802.1AX Link Aggregation

802.1AX-Rev2-d0.1

Editor's Report

Draft 0.1

Figure 6-30—Verification state diagram

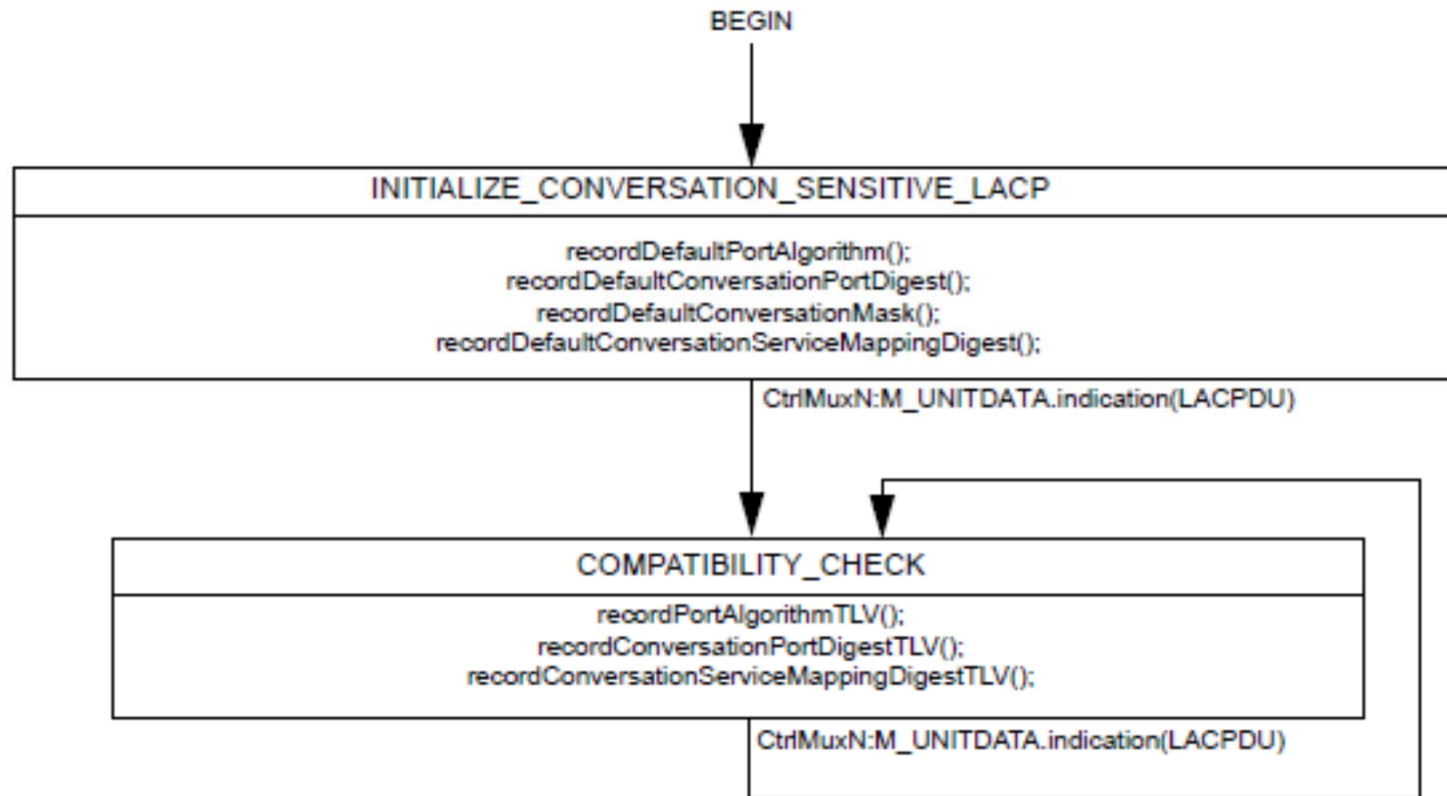
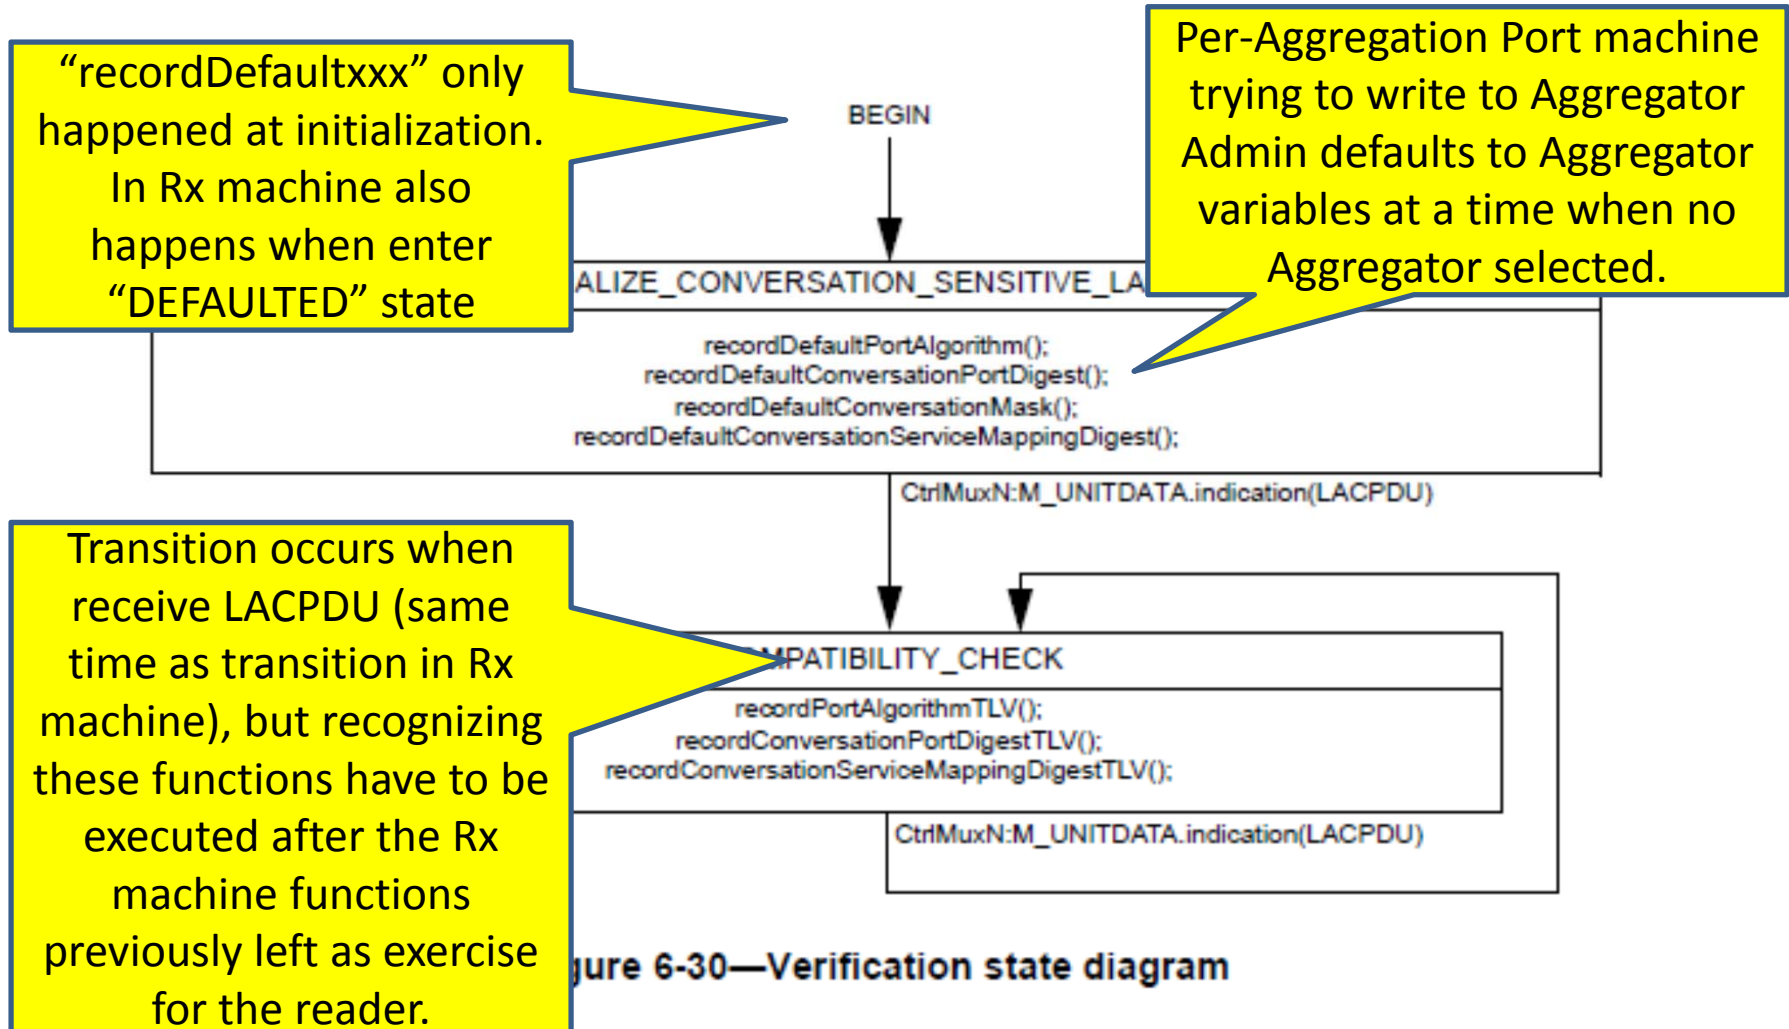
Example: Merging “Verification machine” into Rx machine

Example: Merging “Verification machine” into Receive machine

Figure 6-29—Update Mask state diagram

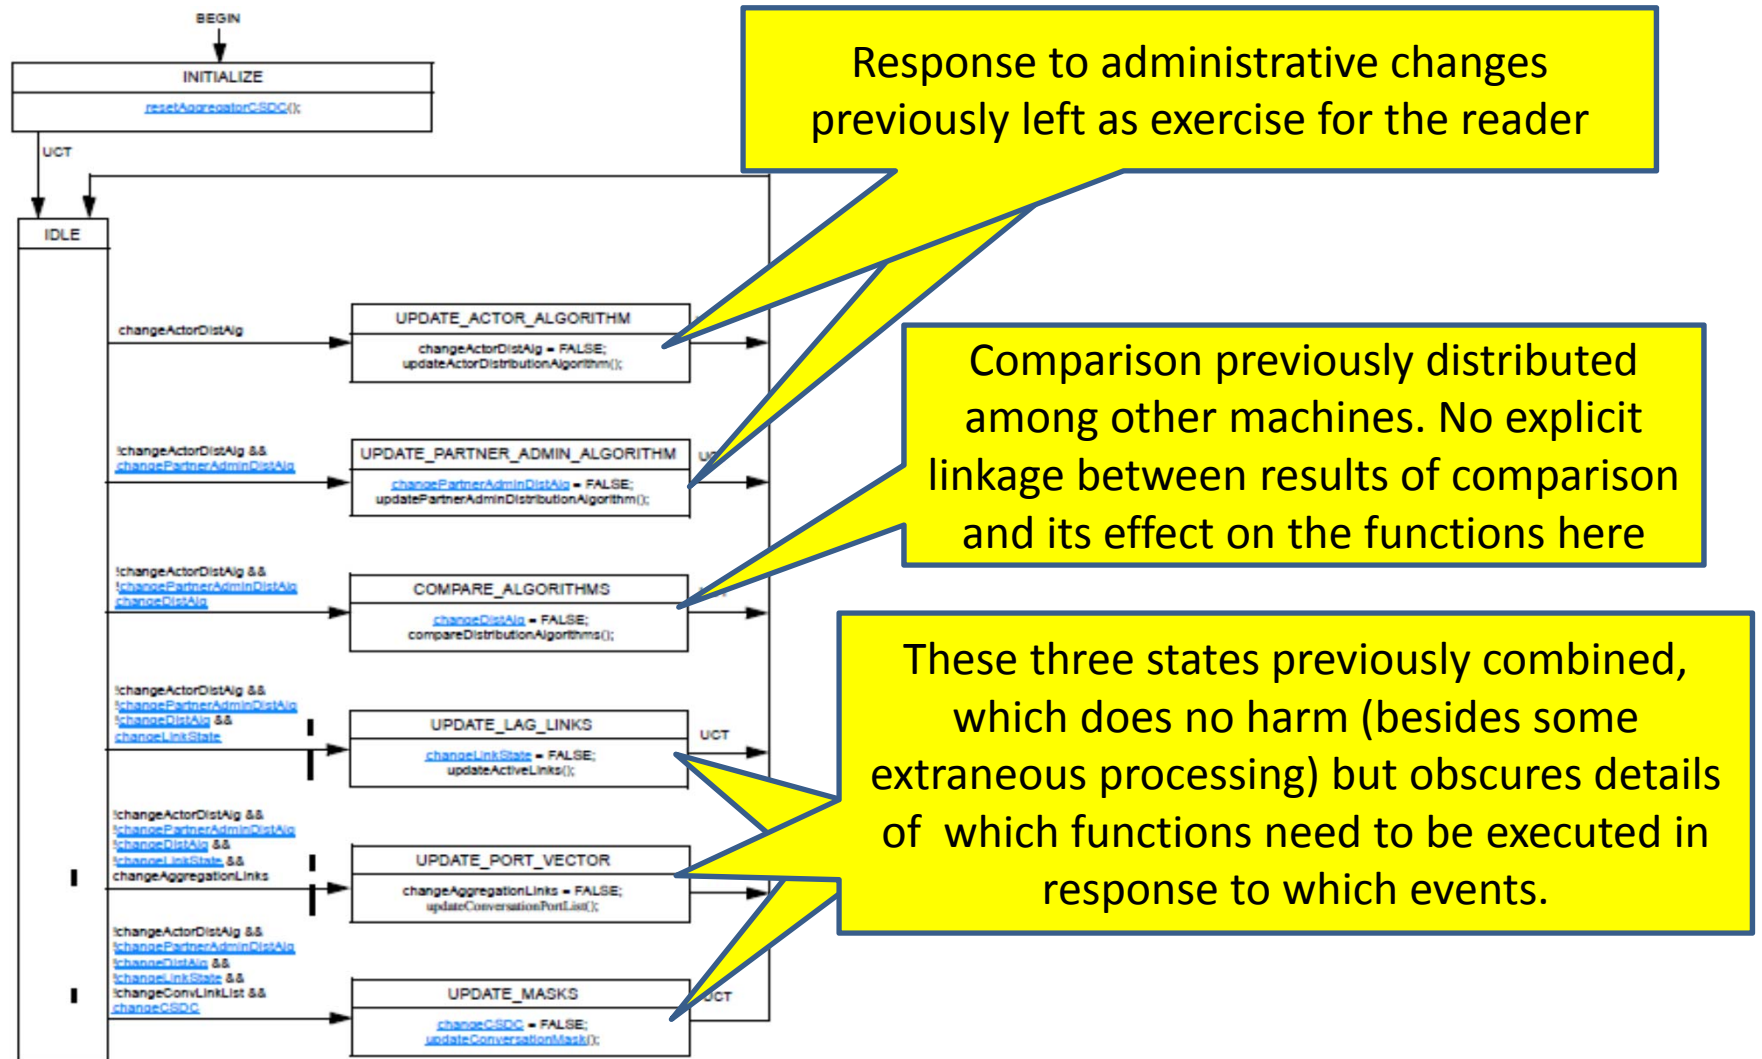
Update Mask Machine
